Western
Pacific
Regional
Fishery
Management
Council

Darell J. Molzan
Environmental Director
Joint Guam Program Office
Office of the Assistant Secretary of the Navy
1000 Navy Pentagon
Washington DC 20350

Because of circumstances explained in our previous letter dated November 10, 2009, the National Park Service (NPS) did not have the opportunity to provide timely comments on the early review Draft Environmental Impact Statement (eDEIS) for the Guam and CNMI Military Relocation. Based on a brief review of the eDEIS and information provided to us during partner meetings, we have ongoing concerns regarding the proposed projects. It is our desire that this letter, with the attached summary of our concerns, be included in the administrative record for the project. The NPS will also provide more substantive comments on the DEIS now available for public review.

Figure 1: Park Units

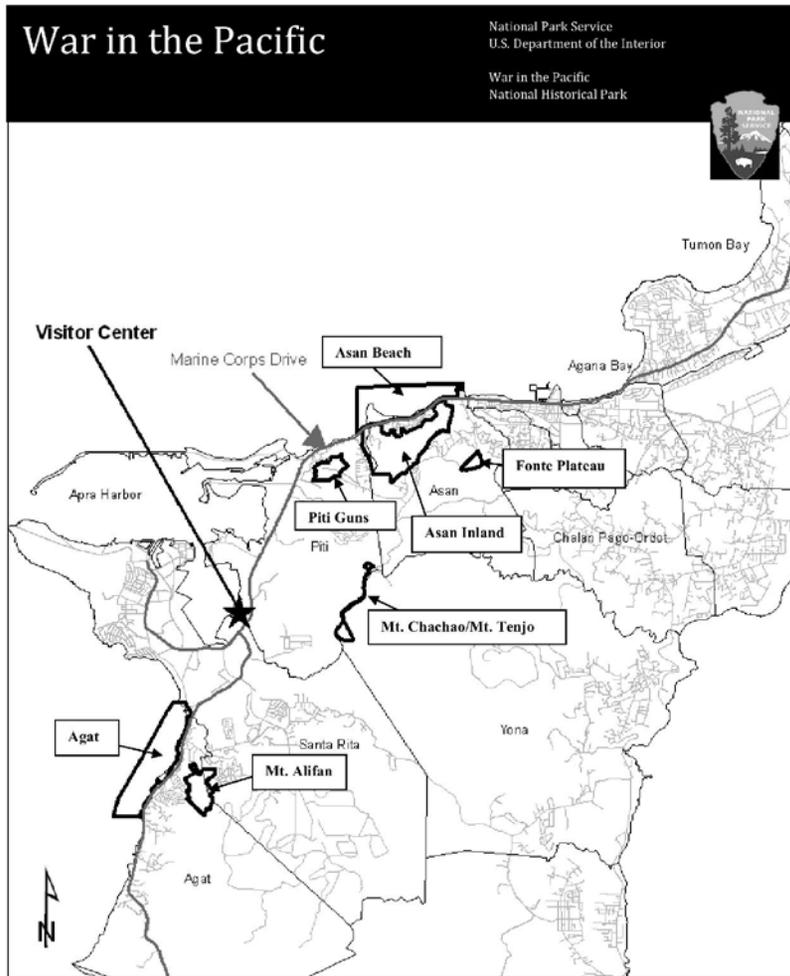
The visitor center is located adjacent to the main gate of Naval Base Guam in a facility leased from the Navy (see Figure 1). It houses an exhibit area and theater, a small bookstore, offices for interpretive staff, and museum collections for both War in the Pacific NHP and American Memorial Park. Individuals and large tour groups visit the center during its open hours seven days a week, year-round. In 2011, the center will house new, permanent exhibits that should attract increased visitation and provide more opportunities for visitors to learn about park resources and values. Parking at visitor center is presently limited on weekdays when adjacent naval offices are busy.

Figure 1

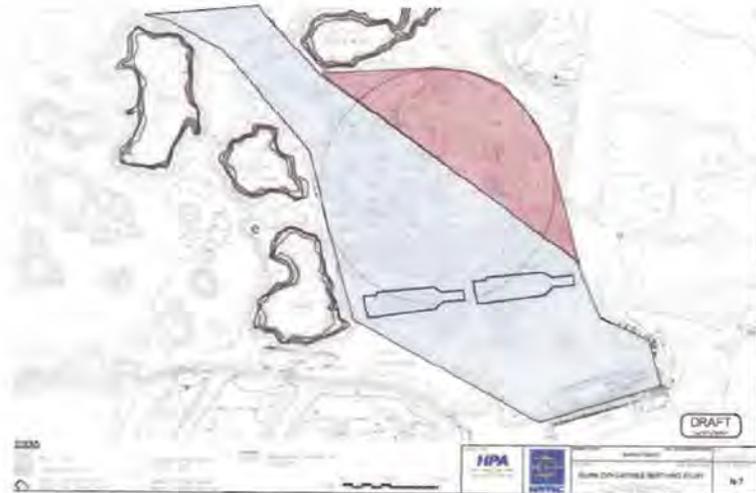
The turning basin, as designed, uses two ship lengths to define the diameter of the turning basin. Below is the scaled diagram provided by DON, depicting the Polaris Point navigation route. In the two figures provided, shaded areas have been overlaid to consider additional options. In the first figure, the burgundy shaded area could be avoided and still retain adequate area within the turning basin. The logic of this option is that the vessel will never have to exit or maneuver toward the Sasa Bay side of the turning basin therefore that space is not necessary. In the second figure, by moving the turning basin within the dredge footprint, additional area could be eliminated from dredging. In addition to the renditions provided, if significant resources were to be defined these paths could be altered slightly to avoid resources.
